ADDENDUM NO. 1
 April 4, 2016
KPYY Waterfront Improvement Program
Kittery, Maine
 BDC PROJECT No. 14-35/36
 STATE WIN: 18561.00

From: Baker Design Consultants
 7 Spruce Road
 Freeport, ME 04032

This Addendum consists of six (6) pages and the following attachments.

7. SHEET R-3 – MOORING SCHEDULE & DETAILS

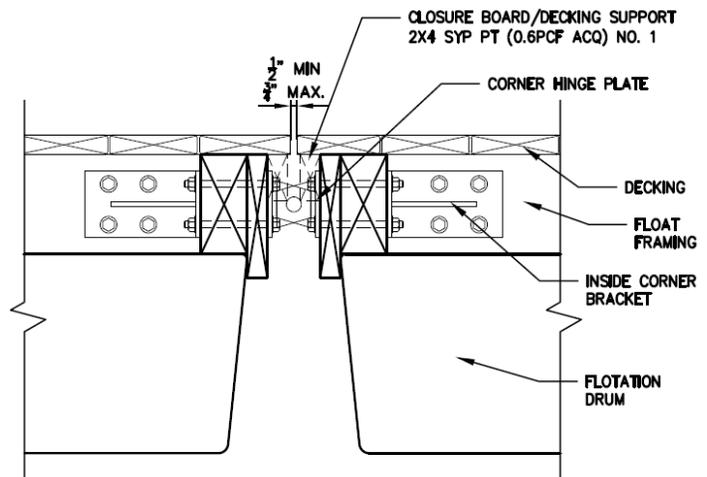
- a. **ADD** the following MOORING TACKLE SCHEDULE;

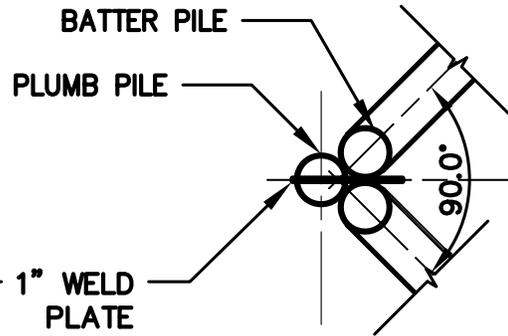
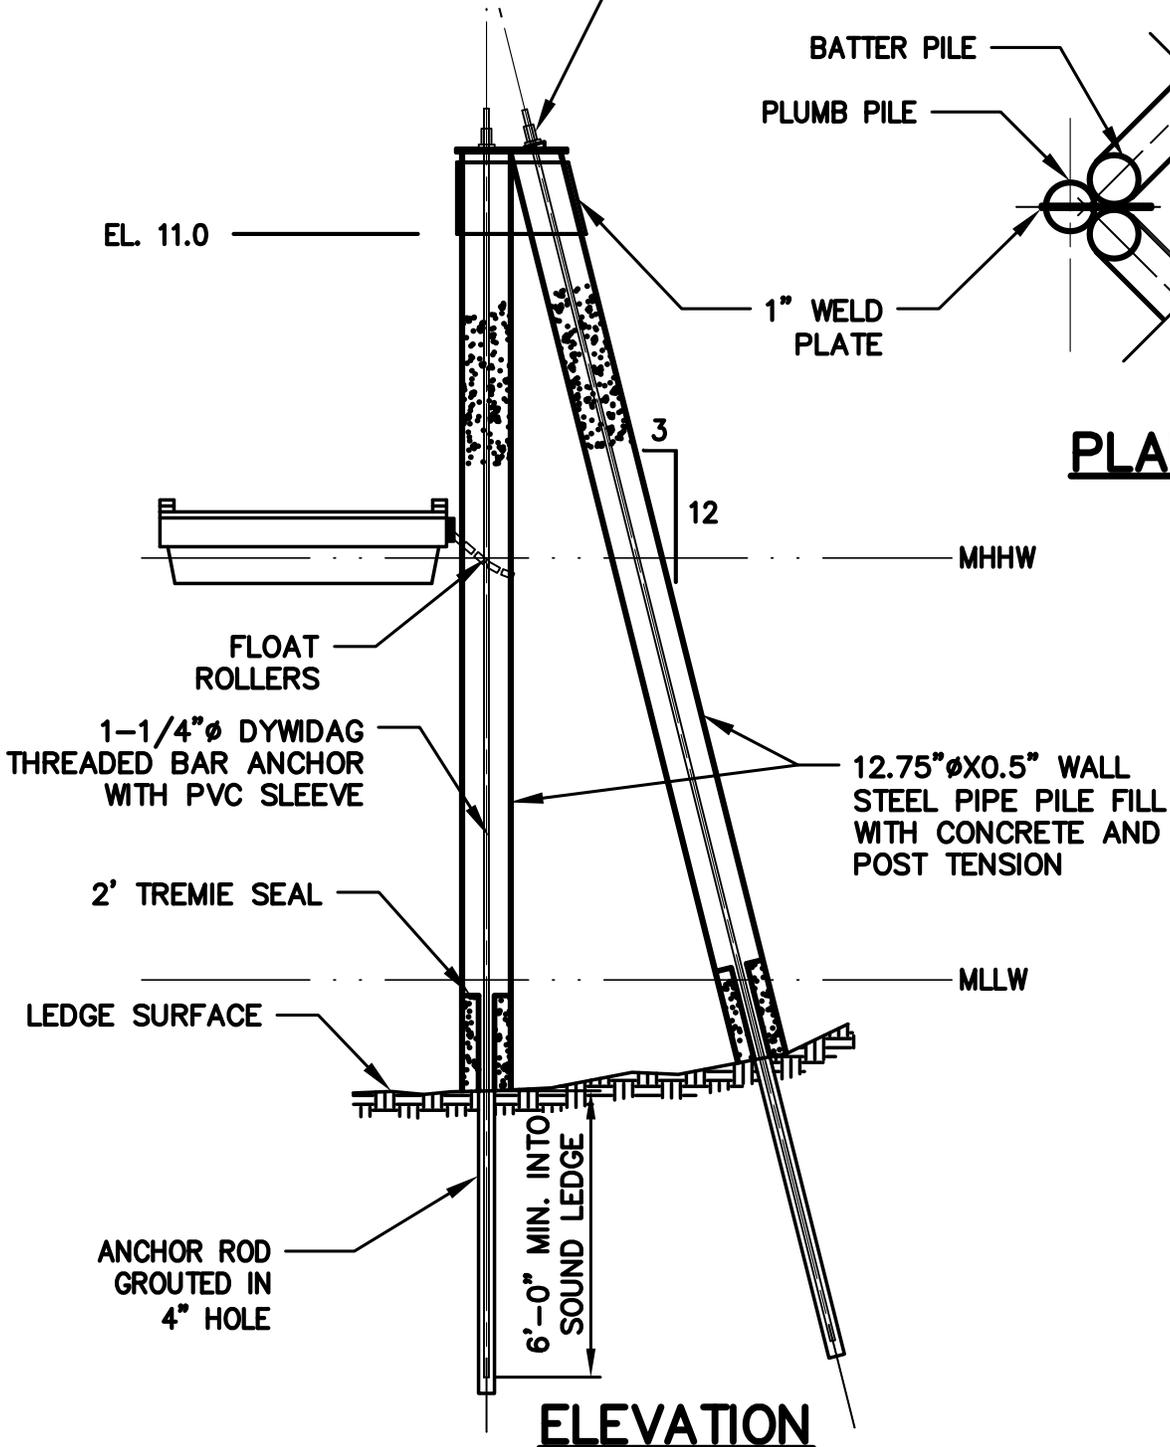
- a. **REPLACE** DOLPHIN DETAIL “3/R-2” with the detail shown in the attached SK-1.
 b. **ADD** DOCK SUPPORT PILE DETAIL shown on attached SK-2 that refers to the Bid Item 7.3 work.

TENSION ANCHOR RODS TO MINIMUM 10 KIP AND SECURE WITH DYWIDAG NUT AND 1" THK SQUARE PLATE WASHER, USE BEVEL WASHER FOR BATTER PILE

TITLE:
**DECK REPLACEMENT
 PILE DETAIL**
 ADDENDUM #1

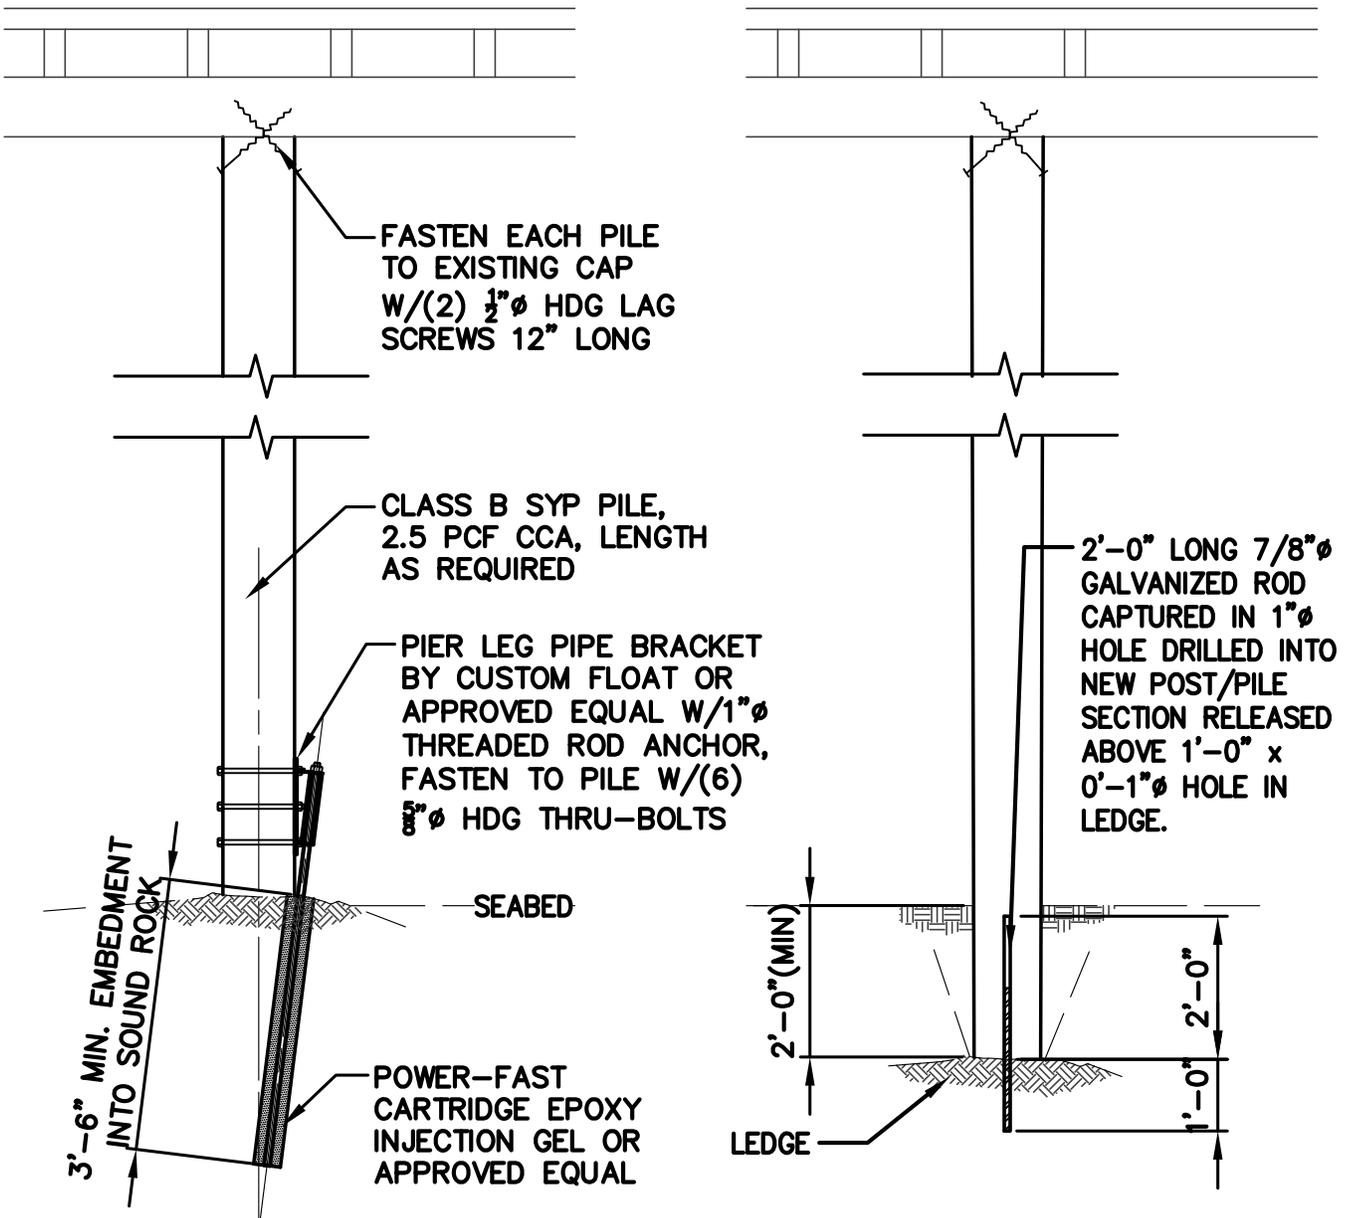
All work, materials and equipment necessary to replace vertical support piles to the existing timber dock in accordance with drawing Sk-2 issued with Addendum No. 1.”
2. SECTION 01025 – MEASUREMENT AND PAYMENT; 1.04 SCHEDULE OF ALTERNATE BID ITEMS; A. EXISTING PIER REPAIRS; **ADD** the following text section:

- CLEAN LEDGE SURFACE. CUT PILE TO FIT FLUSH WITH LEDGE.
- PLACE PILE AND COMPLETE TOP CONNECTION.
- INSTALL BRACKET AND DRILL HOLE IN LEDGE USING BRACKET AS GUIDE.
- INSERT ANCHOR ASSEMBLY IN EPOXY GROUTED HOLE. SPIN TO REMOVE AIR BUBBLES.
- SECURE TOP NUT ON ANCHOR ROD.
